**FINAL DRAINAGE REPORT
ADDENDUM NO. 2
BENT GRASS RESIDENTIAL FILING NO. 1
FOR
BENT GRASS EAST COMMERCIAL
FILING NO. 3**

PCD Filing No.: SP-20-010

Job no. 2177.64

DEVELOPED DRAINAGE MAP

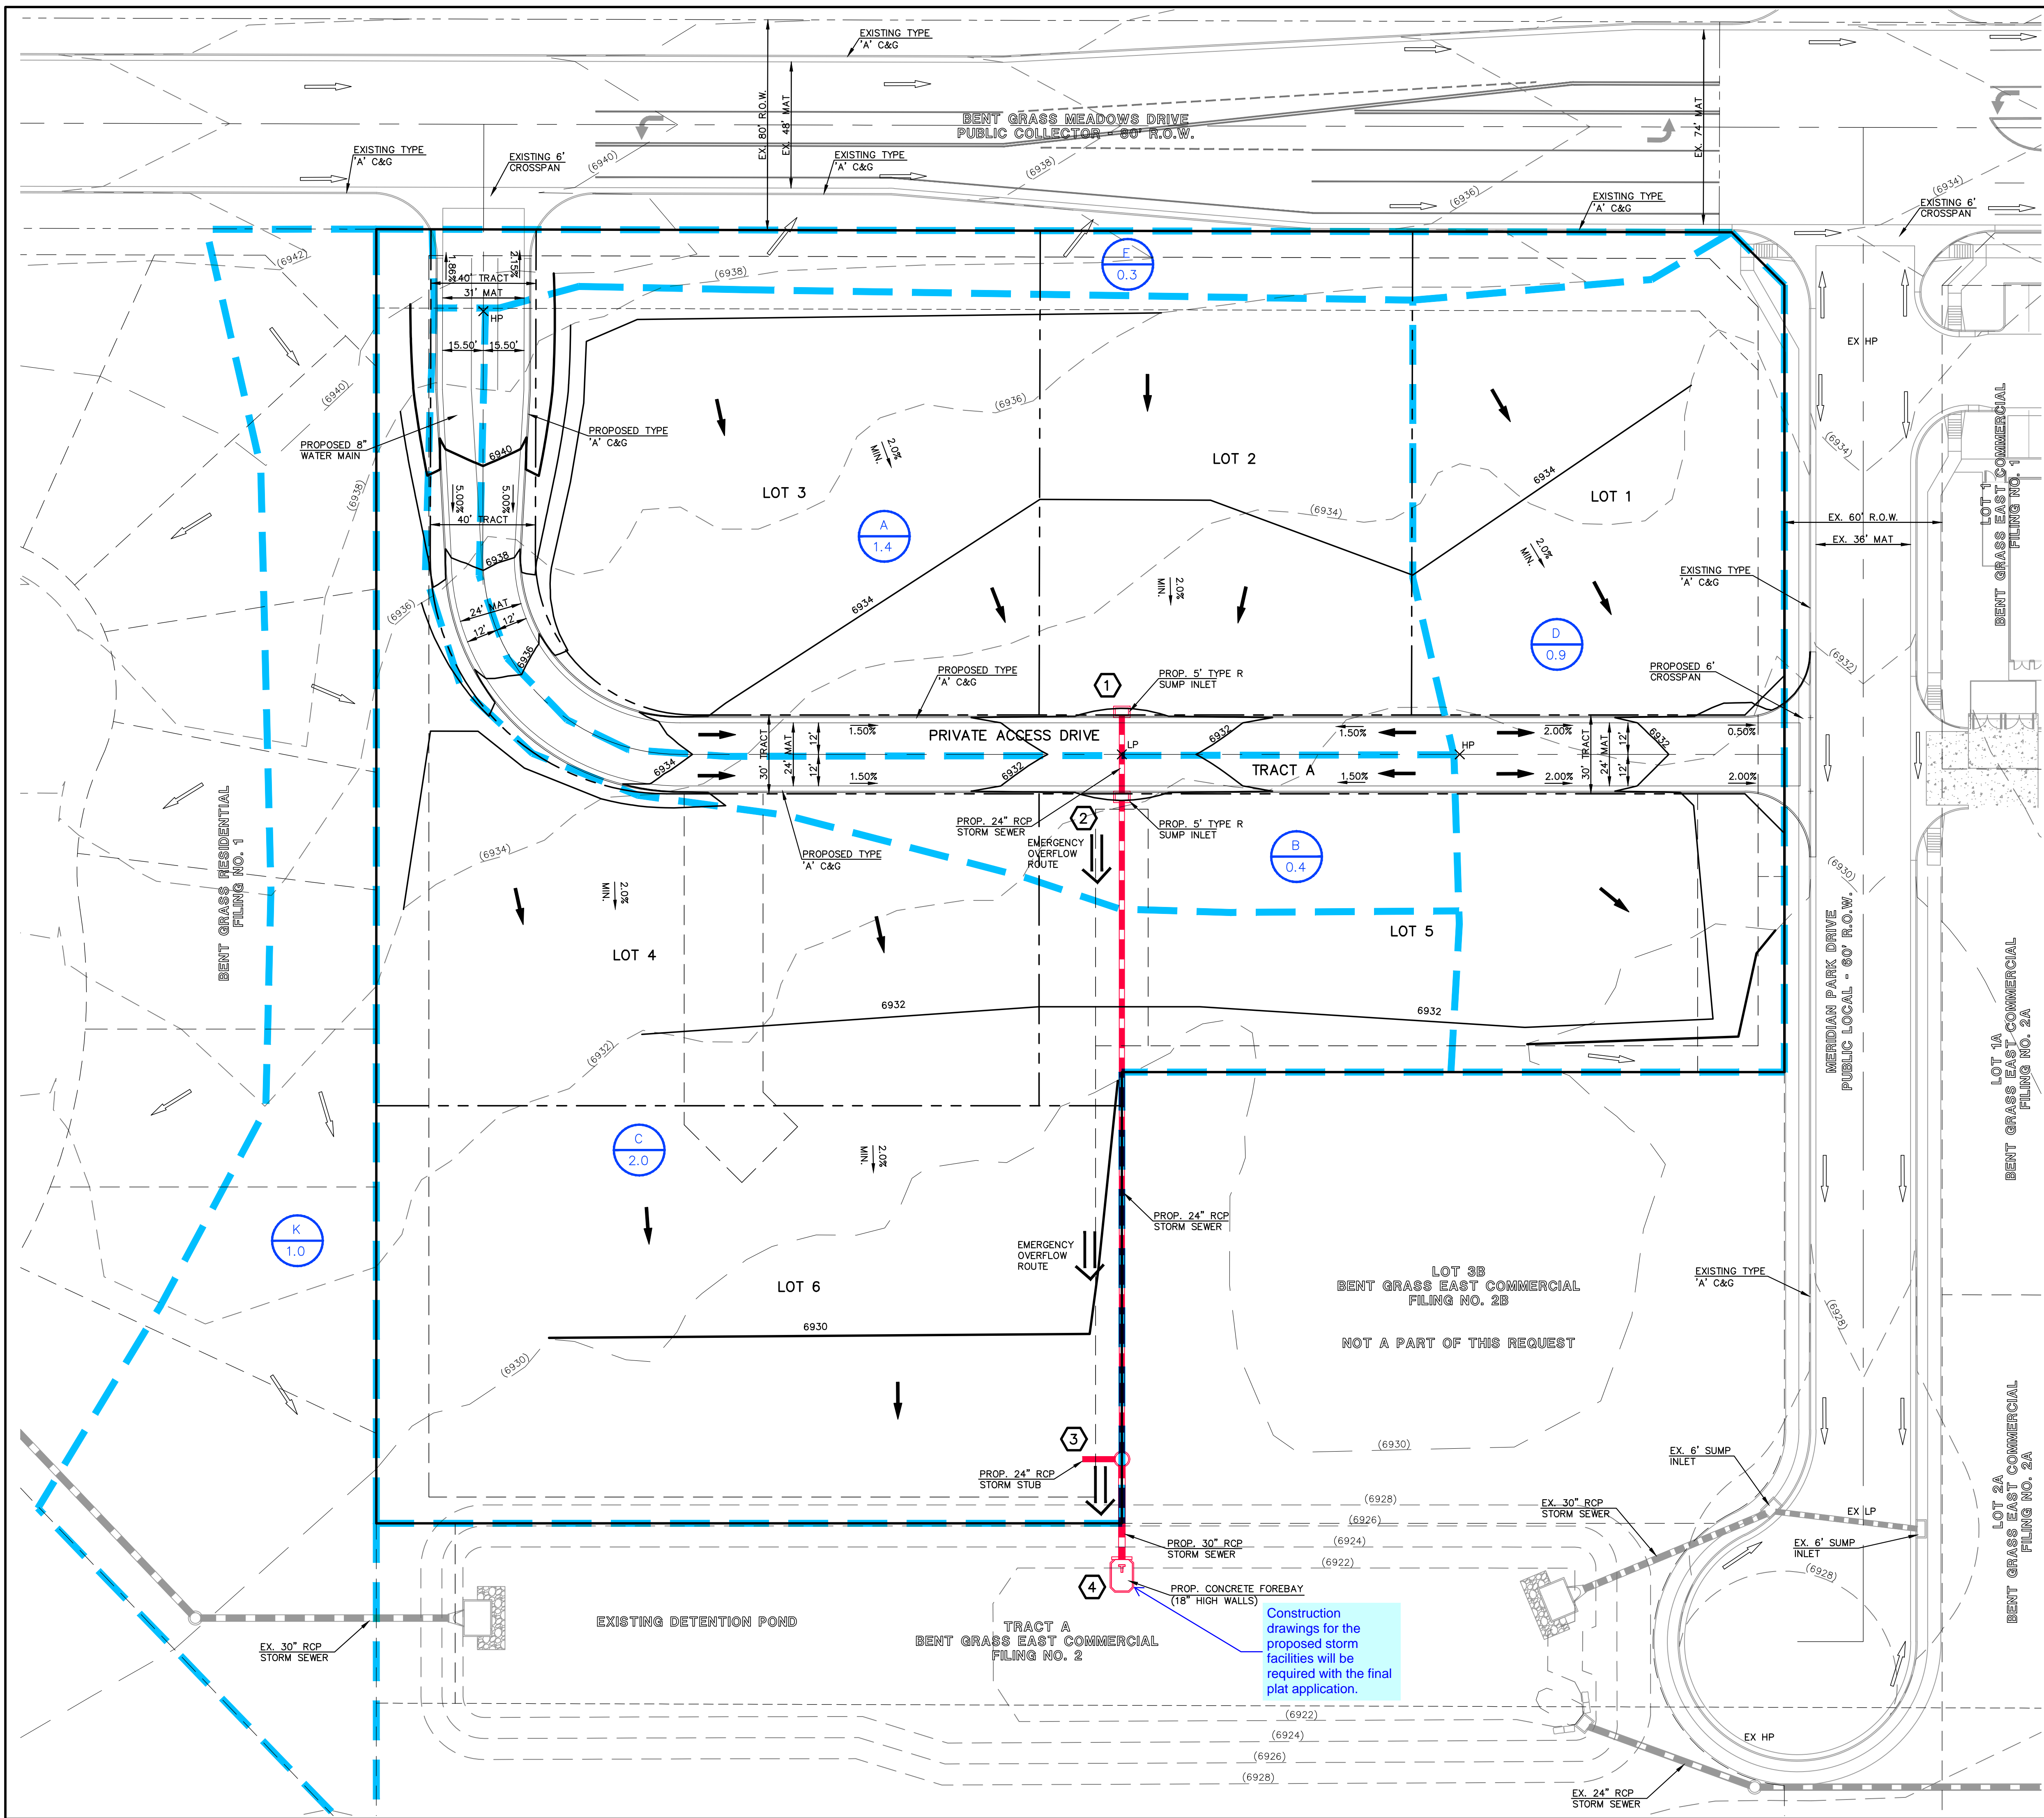
Per the drainage map, it appears that the majority of the runoff from basin C will sheet flow into the pond as opposed to being routed to the 24" RCP. Is the intent for the 24" RCP to be capped for connection by the developer of lot 6? Revise accordingly.

Please indicate how these flows are conveyed to the existing pond.

please provide a table with your calculated basin/design point flows as done with the previous drainage map in the next page.
